REMARKS

Appln. No. 10/760,655
Amendment dated August 27, 2004
Reply to the Office Action of June 30, 2004

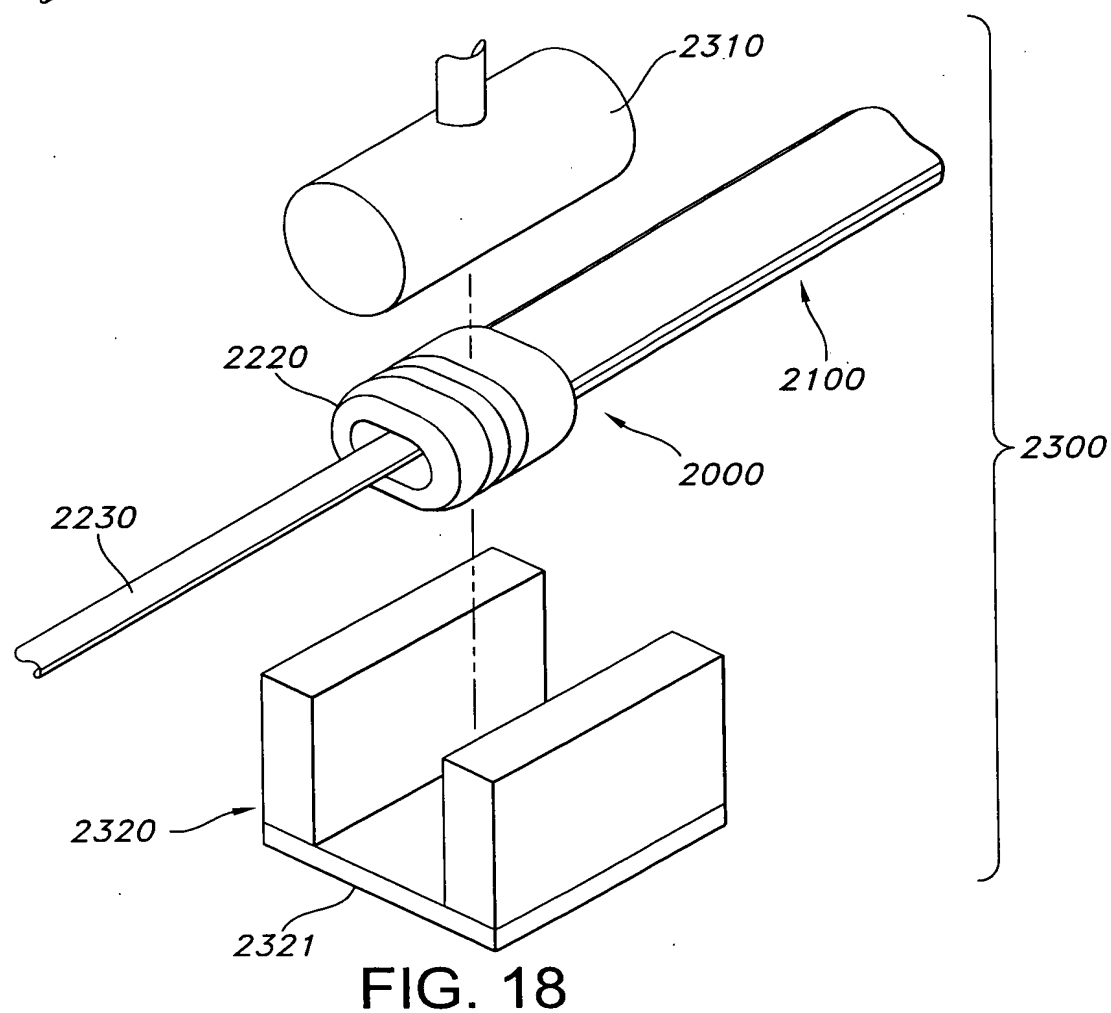
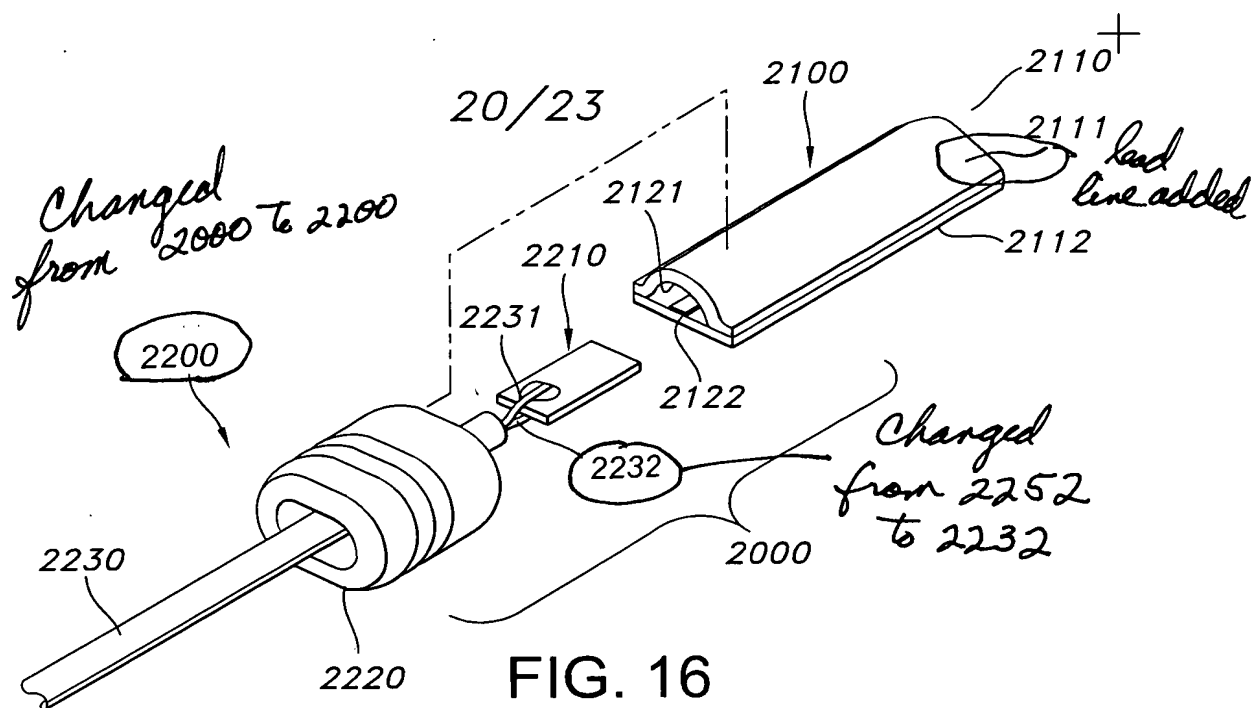
The drawings are objected to. In particular, regarding FIG. 16, element 2111 was not connected to any feature, and there were two numerals 2000. At page 44, line 13 of the specification element 2200 was not shown in the drawings. These informalities have been addressed by adding a lead line to numeral 2111 showing the feature to which it is connected, and changing one of the numerals 2000 to 2200.

In FIG. 16 element 2252 has been changed to 2232. The connected feature is a wire lead as identified at page 45 line 14 of the specification as 2232.

FIG. 17A

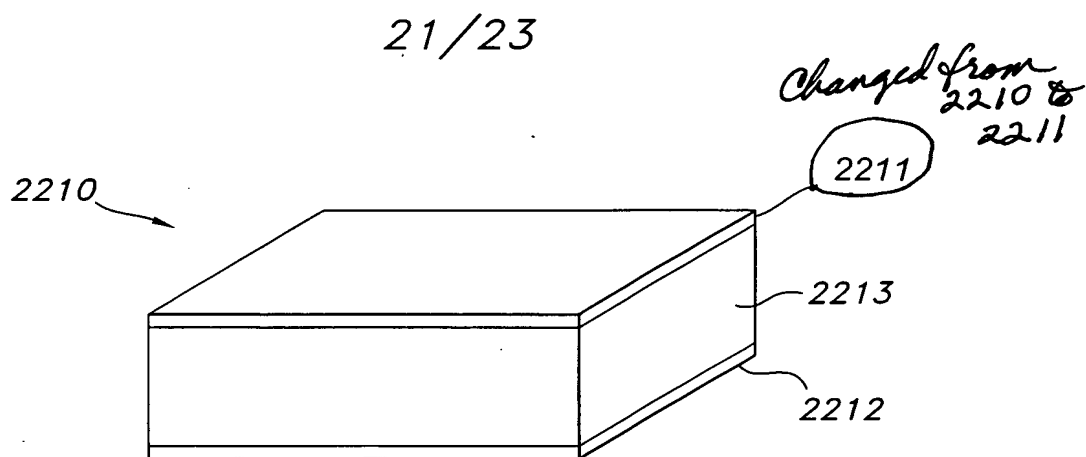
In FIG. 17A the conductive contact electrode 2211 (see, page 44, lines 14-18 of the specification) had been erroneously numbered as 2210. This is corrected by amendment herein.

FIG. 19

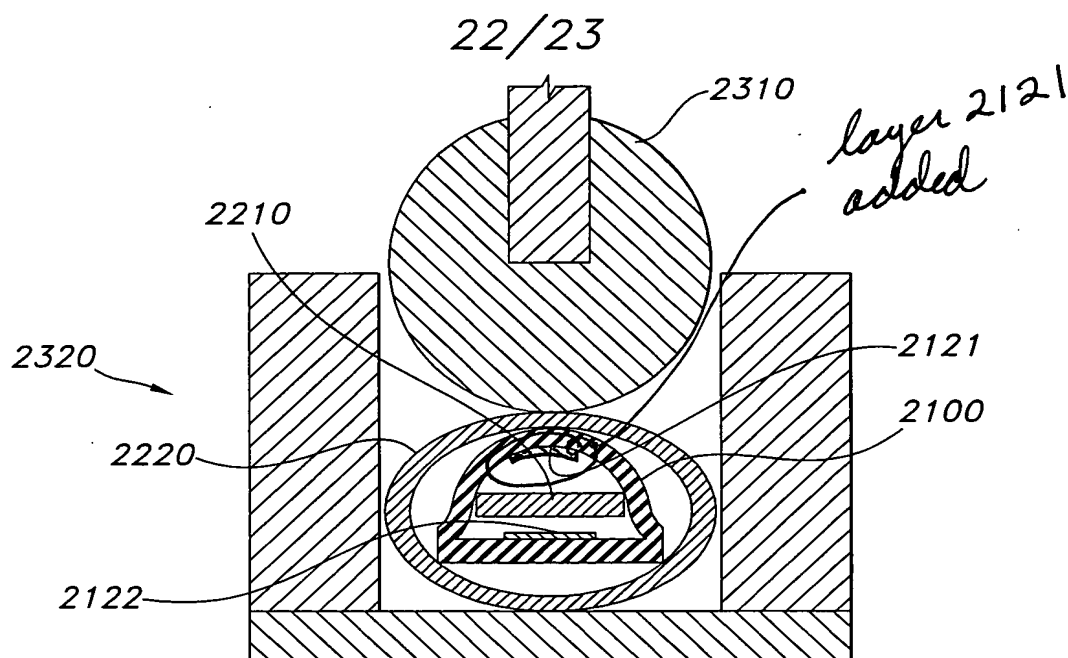
In FIG. 19, the feature to which numeral 2121 is connected, i.e., a conductive electrode film, is added by amendment.
